LAOLING BOYU BUILDING HARDWARE CO., LTD. 乐陵市博宇建筑五金有限公司 JINAN RUQI TRADING CO., LTD

传动器改进说明

Transmission improvement instructions

新款 the new

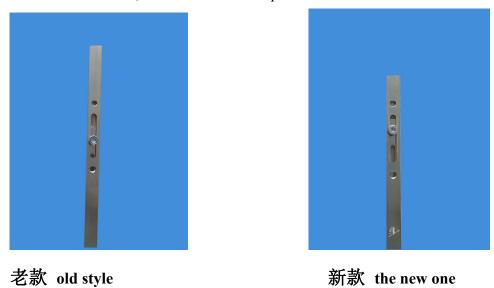
老款的传动器锁点是空心的,在下雨时容易进水,影响使用效果。新款传动器锁点 是实心的,质量更好,更持久耐用。

The lock point of the old transmission is hollow, which is easy to get water when it rains, which affects the use effect. The lock points of the new actuators are solid, better quality and more durable.
